**Hallam Land Management Limited, St Albans School, and St
Albans School Woollam Trust**

Woollam Park, Land at North St Albans

Hydraulic Modelling Addendum

Document Ref: 05920-WR-HMR-02

Figure 3-1 Post Development Model Updated Build

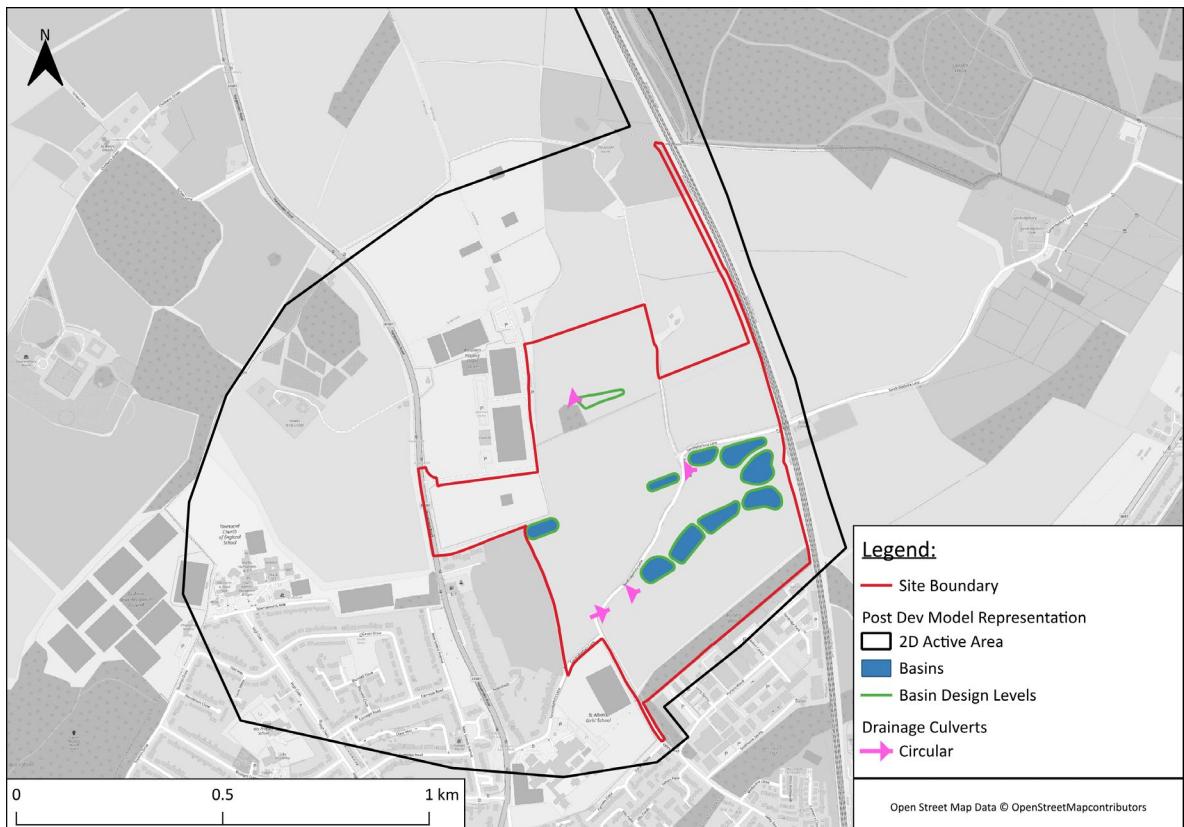
3.2.2 The changes to the Post Development Model comprise the minor modifications to the positioning of the Basins D and L, with the following layers amended in the model:

- Proposed Earthworks Surface – surface has been amended, relocation of the two surface water drainage basins (Basins D and L) to the west.
- Structures – one proposed drainage culvert has been removed..
- Storage feature water levels – initial water level representation has been shifted to the west, aligning with the updated proposed levels and position of Basins D and L.
- Basin design levels – cover levels for the basins have been re-aligned with the updated proposed levels .

Figure 4-1 Post Development Model Flood Extents

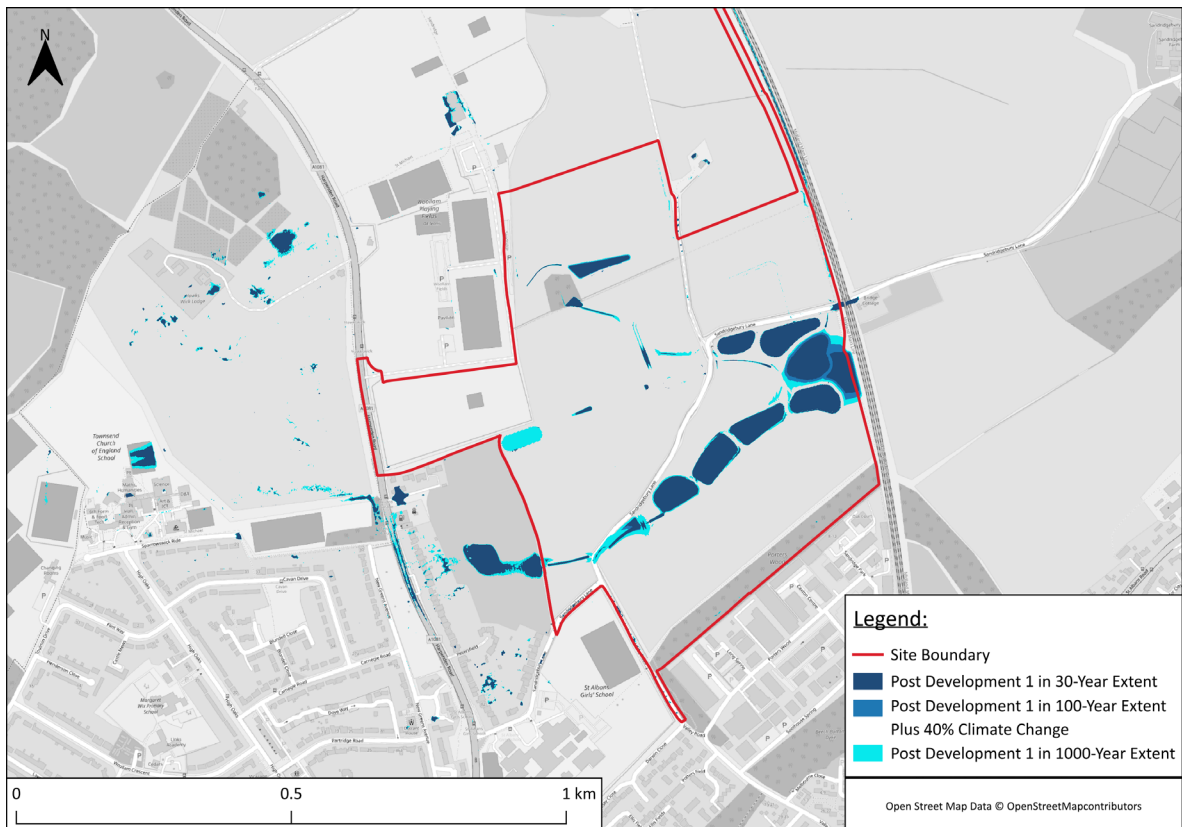
- 4.1.3 The updated Post Development Model extents remain consistent with those previously identified in the Post Development Model as summarised in the supporting hydraulic modelling report (Ref. North St Albans- Hydraulic Modelling Report, 05920-WR-HMR-01-P2).
- 4.1.4 The updated Post Development Model maximum peak water levels remain largely consistent with those previously identified in the Post Development Model, as summarised in the supporting hydraulic modelling report (Ref. North St Albans- Hydraulic Modelling Report, 05920-WR-HMR-01-P2), with some minor variation identified in each of the modelled events.
- 4.1.5 Table 5-1 shows a comparison of peak water levels, within the Site adjacent to the existing railway embankment, between the Post Development Model, as summarised in the supporting hydraulic

modelling report (Ref. North St Albans- Hydraulic Modelling Report, 05920-WR-HMR-01-P2) and the updated Post Development Model.
